DATE: May 20, 2020

TO: Design Review Commission
FROM: Sean K. Gallegos, Associate Planner
SUBJECT: V20-0001 and SC20-0001 – 725 University Avenue

PROJECT DESCRIPTION

TO: Historical Commission
FROM: Sean Gallegos, Staff Liaison
SUBJECT: H20-0001 – 725 University Avenue

Standard #9

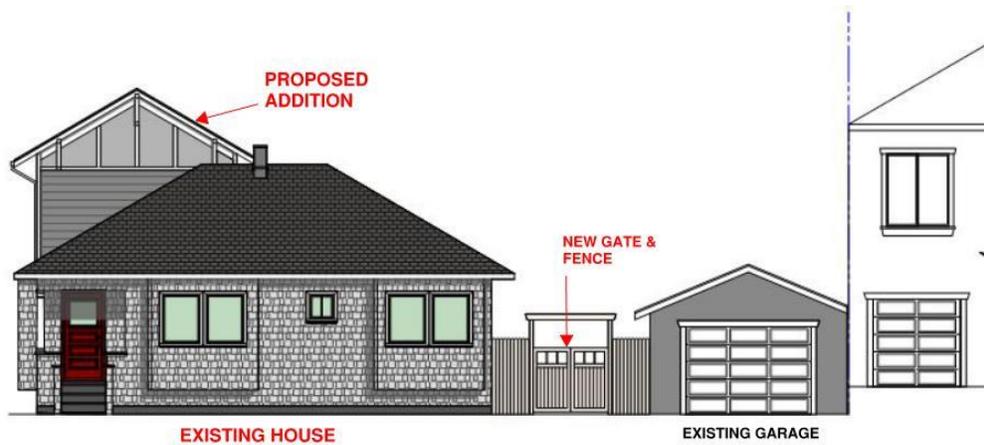
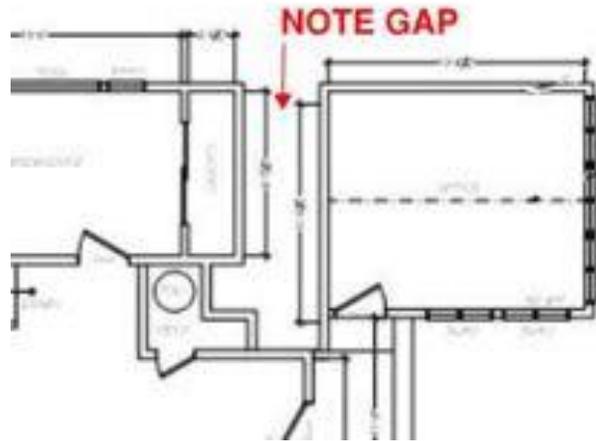
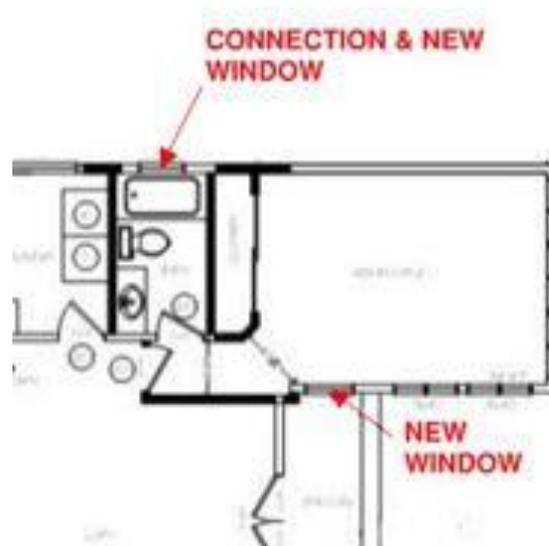
Comment:

On Monday March 2nd, the property owner, Eric Albert and Assistant Planner Sean Gallegos met to discuss the project. Mr. Gallegos asked for a commentary on how the new work would be distinct from the existing to informed observers. This request is pertinent to Standard #9:

This standard seeks to discourage “false historicism”; however, implicit in this standard is the idea of scale and quantity. The application is commonly understood to address larger additions with additional footprint, or additions that add substantial height. For example, the following project involves a rear, connected two story addition to a small, simple craftsman house constructed in 1906. The application of this standard is rigorous in creating distinctions between the original house and the addition using a diminished footprint, mass, cladding materials and color. The task is to allow the original house to predominate while clearly making a distinction

The project at 725 University Avenue is comprised of disparate elements located out of view, for the most part at the heavily altered rear of the property. Because there is no single addition or additional footprint, and the alterations are small in scale it is architecturally difficult to make a distinction between the original fabric and the new work. For example: the project proposes connecting the discontinuous spaces at the northeast corner of the second floor which requires a new wall that aligns with the two original walls:

To use a differ cladding material to make a distinction at this type of architectural condition at this scale serves no purpose relative to the intent of Standard #9. Similarly, the proposed window removal to be replaced with a French door on the rear elevation, does not lend itself to an observable or material distinction. The only option for making a distinction would be to use a sliding glass door which is not compatible with the architectural language of the house.

On the other hand, the original design proposed a dormer at the front elevation, observable from the street. Based on the character defining features described in the DPR forms, the main roof lines are important and the addition at this location would compromise the building's character and add an observable inappropriate feature. The design team opted for the use of skylights at this location as an alternative. This decision complies with Standard #9 in that it makes clear that this feature is new, very low profile, and architecturally neutral in terms of the architectural language.
